## **Answer to reviewers**

## Reviewer 1

## Reviewer 2

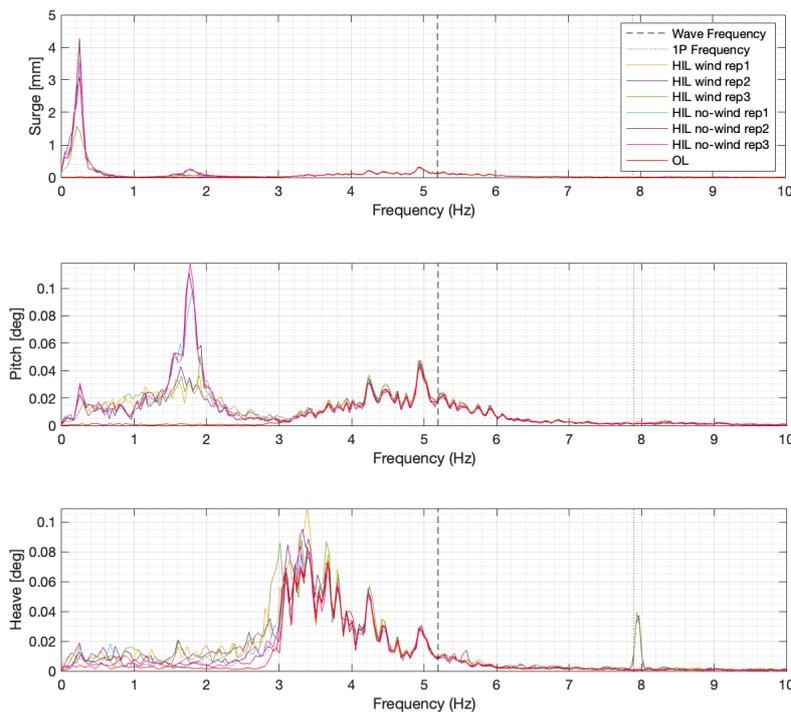
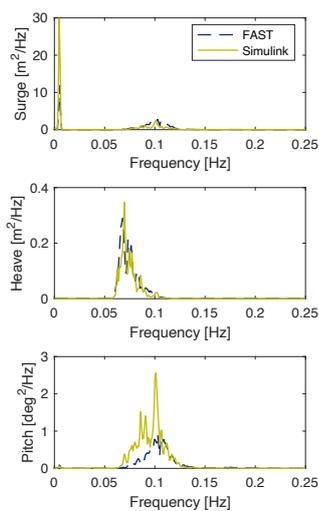
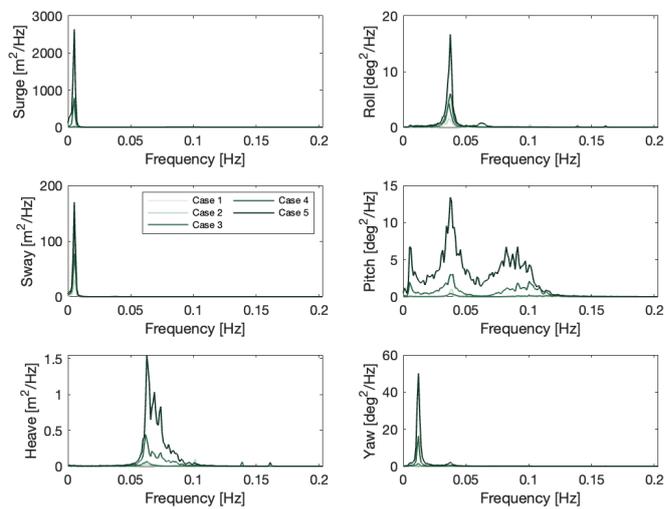
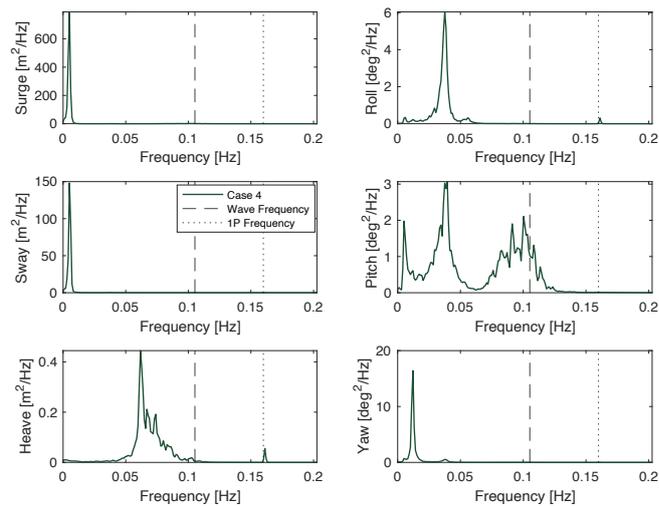
Similarly, in Figure 5, I think plotting only the PSDs in log scale can be misleading, and showing the time series on a given sample of ~300 s full scale could help visualizing the agreement and the effect of delay.

Figure 5: plotting only the PSD in log can be misleading (particularly on the Surge and Pitch). Could you add a time series comparison, on a sample of ~300 s? (several low frequency oscillations)

For the current topic, a quantification of the error on the wave frequency amplitude and on the pitch and surge response amplitude at the natural frequency would be relevant to add.

Figure 5, instead, shows the motion response to wave loading of the Simulink floater model in comparison with FAST (benchmark). Both are pure simulations performed in a standalone modality (i.e. the experimental setup was not in use), and therefore, the reasoning on delays is not relevant to this result, neither with regard to delays induced by the actuation of the hexapod nor those induced by the HIL loop. However, the latter can influence the results shown in Figures 10 and 11.

Figure A7 (previously A8), added in the previous review round, can be useful for this matter, by showing a time history of position together with measured forces and accelerations and estimated aerodynamic force. It shows a 250s sample at full scale (5s at model scale).

PDSs in Figures 5, 10 and 11 have been kept in log scale because, upon trying, the linear scale was not found suitable to show the result. However, for completeness, the PSDs in linear scale are reported here (figures 10, 11 and 5 in this order):

One can refer to Figure A7 (previously A8) for a visualisation. The PSDs in linear scale have been added to this document (see above), but were not found suitable for the manuscript because the linear scale leads to a poorer visualisation of the result, for the present case.
